ARBORIST REPORT

18151 OVERLOOK ROAD
LOS GATOS, CALIFORNIA

PROPERTY OWNER: Ronald M. Tate
APPLICANT: Nicole King of Urban West, LLC
ARCHITECTURE & SITE APPLICATION S-14-056
APN 510-40-146

David L. Babby
Registered Consulting Arborist® #399
Board-Certified Master Arborist® #WE-4001B

SITE & DRAINAGE PLAN

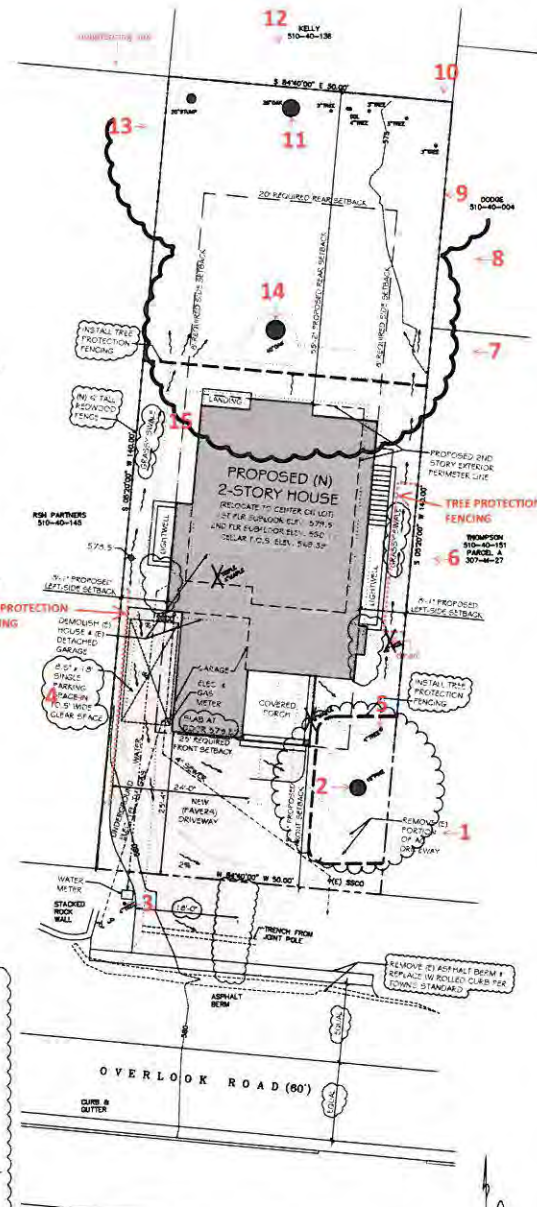
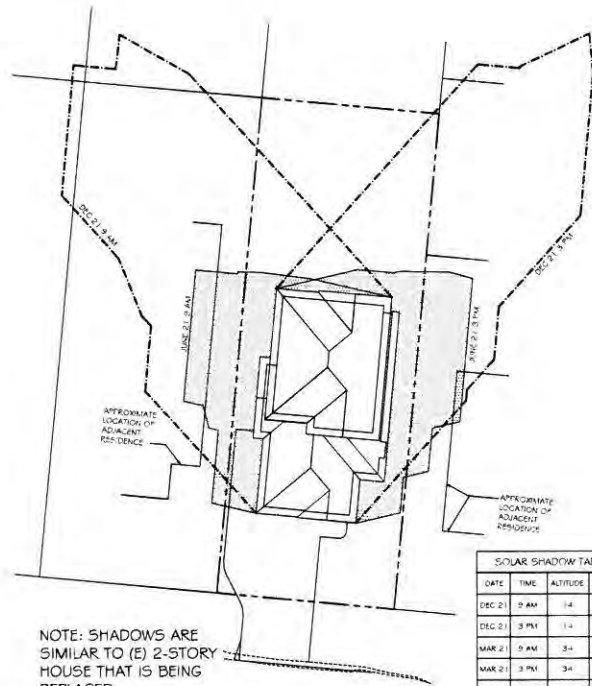
6. Add the **assigned numbers** to all site-related plans. The approximate **trunk locations** of **#1, 4, 6-10, 12, 13 and 15** should also be added, as well as additional information regarding the grade differential, planter width and wall location beneath **#4's** canopy.

11. On Sheet A1, add **protection fencing** for **trees #4 and 6** to be along the outside eastern edge of the existing wall for **#4**, and five feet from the proposed home foundation or basement wall for **#6**; see Exhibit B for an illustration.

12. A **root zone buffer**, for foot-traffic only, should also be specified on Sheet A1 for **trees #6 and 14**, to be between protection fencing and the basement wall or foundation. It shall comprise a six- to eight-inch layer of coarse wood chips manually spread on unpaved ground, and to create a sturdy walking surface, can be covered by plywood sheets of at least ¾-inch thick and secured together. For **tree #6**, it should be installed prior to demolition, and for **#4**, immediately following removal of the existing rear patio.
